Monitoring Year 2 FINAL Monitoring Report
Stewarts Creek Tributaries Stream Restoration Project
Surry County, North Carolina
Yadkin River Basin, Hydrologic Unit Code (HUC) 03040101

NCDEQ Contract No. 7183
DMS ID No. 100023
RFP#16-006993
USACE Action ID No. SAW-2017-01508
DWR ID No. 20171043

**RE: Response to Draft Monitoring Year 2 (MY2) Monitoring Report Comments dated December 9, 2021
Stewarts Creek Tributaries Stream Restoration Project
Yadkin River Basin –HUC 03040101 – Surry County, North Carolina
NCDMS Project # 100023, Contract # 7183**

Stewarts Creek Tributaries Stream Restoration Project Year 2 (2021) Streamflow Data

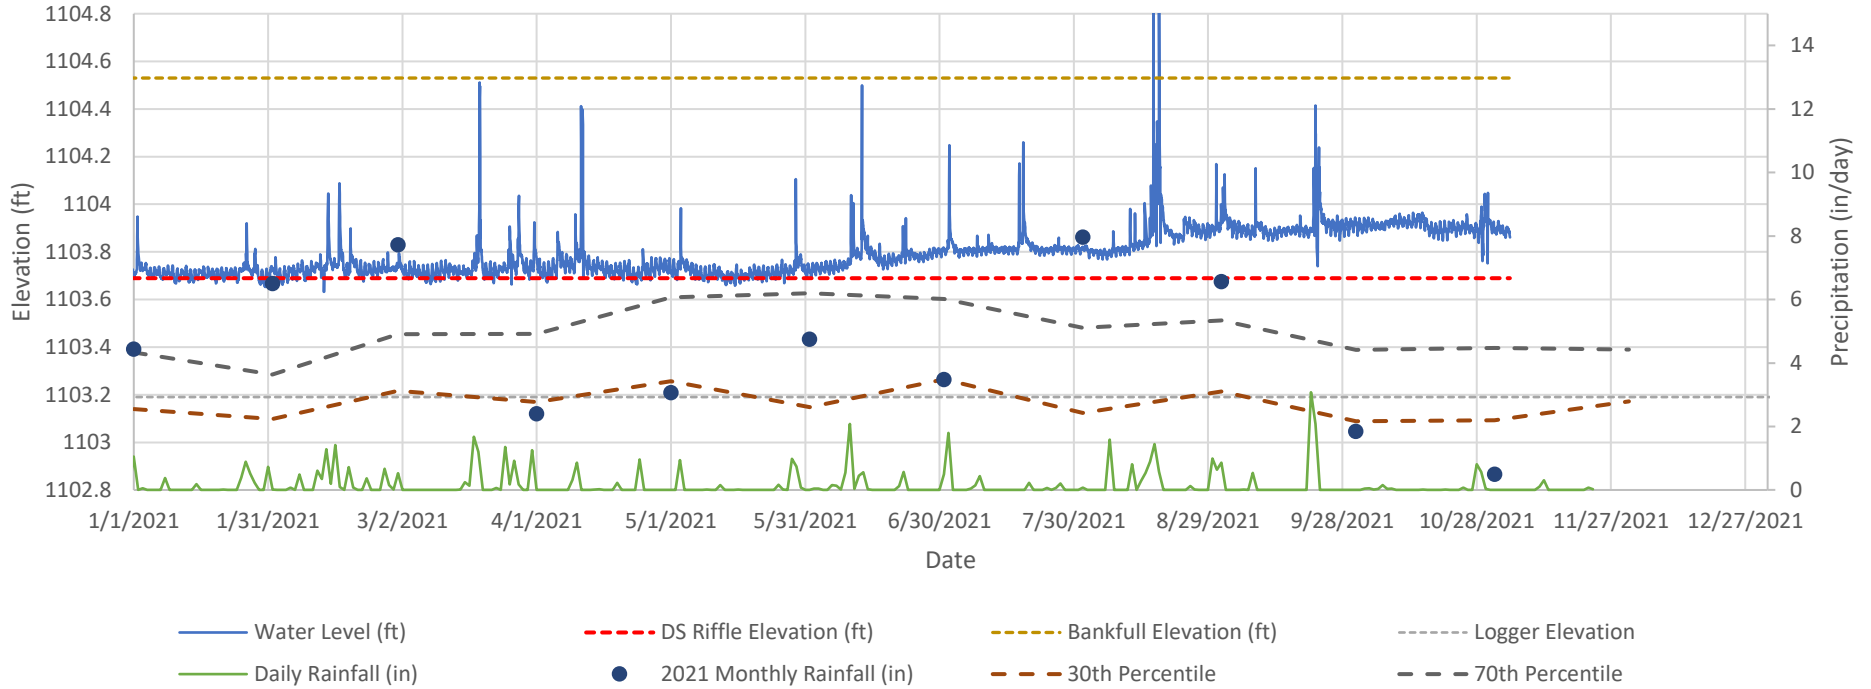
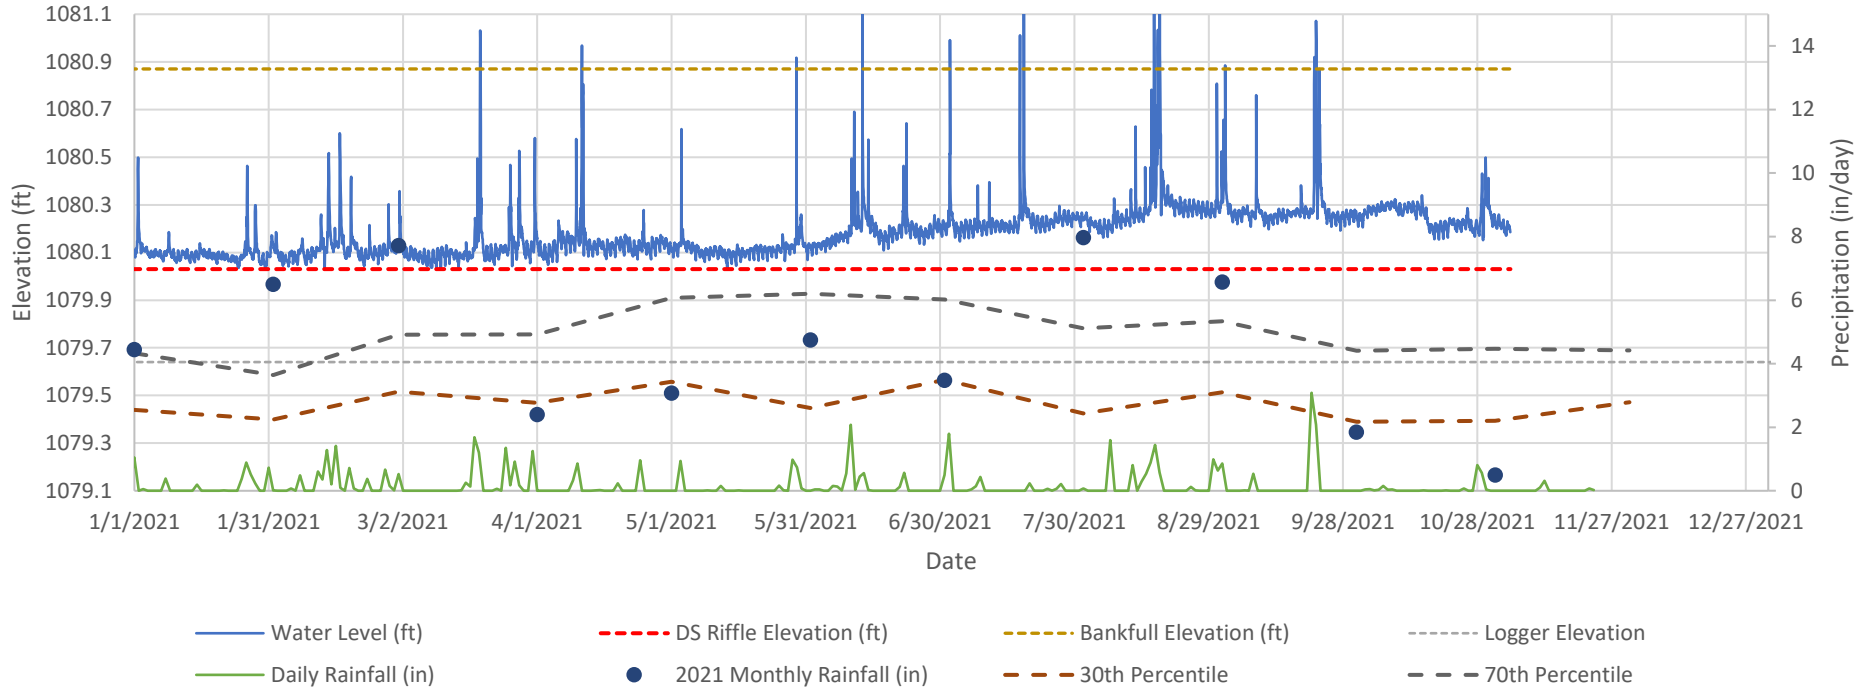
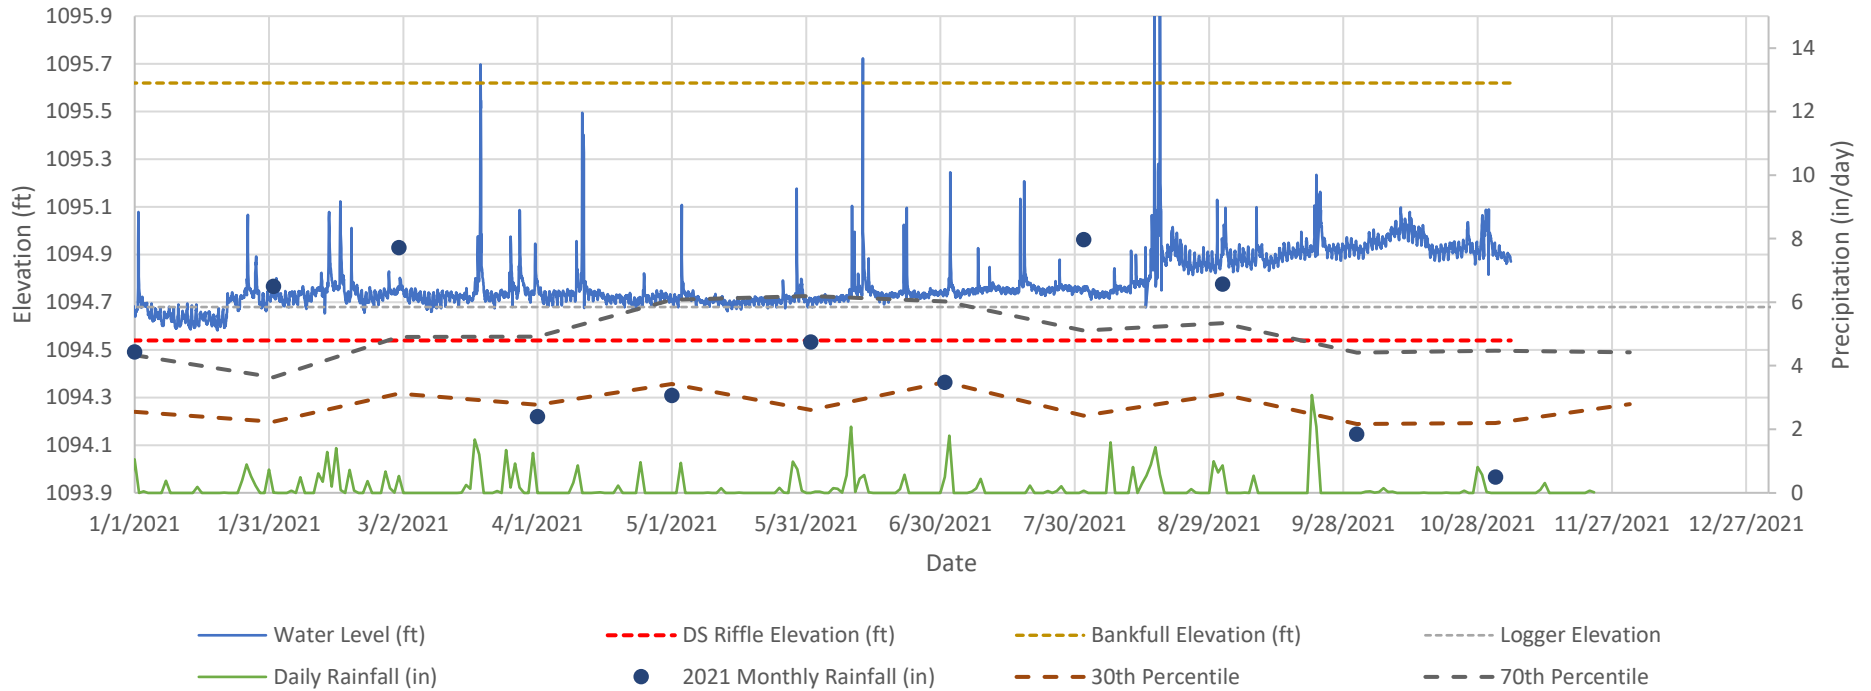
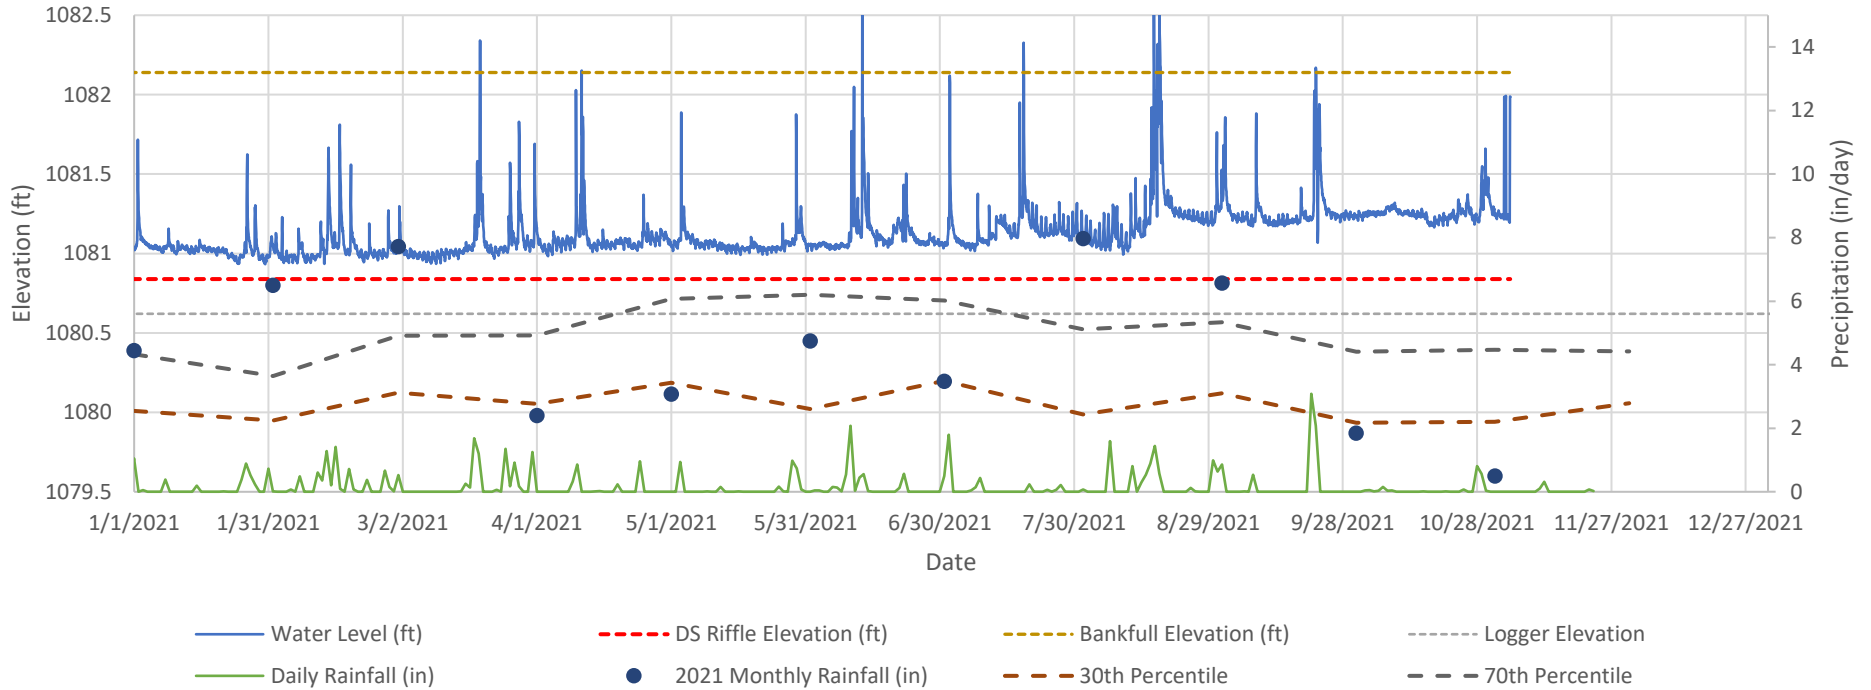
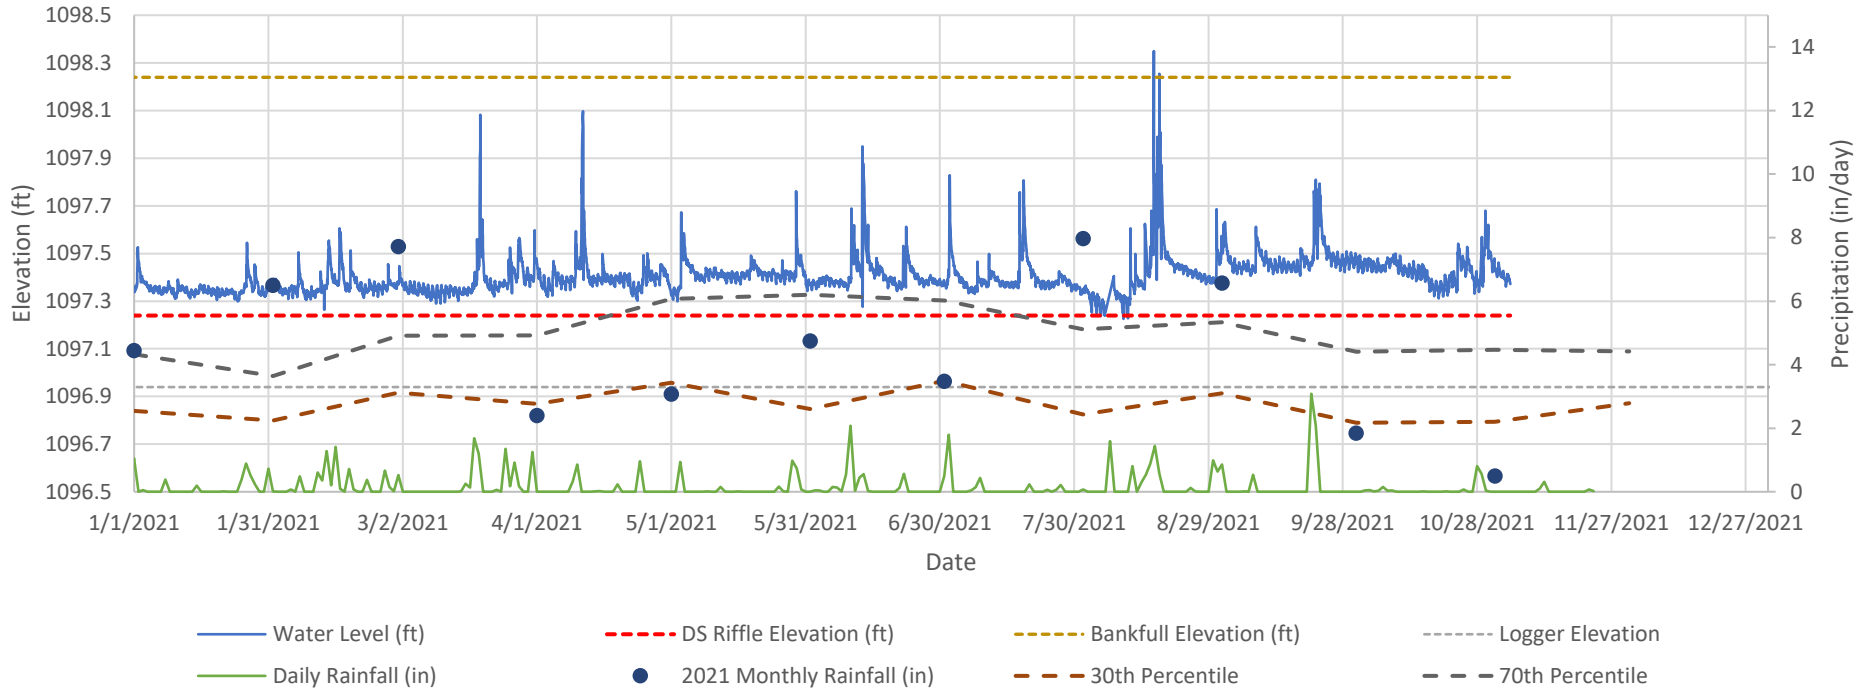
- *Digital Support Files: Please include the daily precipitation data used in the stream gauge figures and ensure these data are consistent across excel workbooks.*
 - **This data is now included in the SCT_100023_MY2_GW and Precip.xls file in supporting files.**
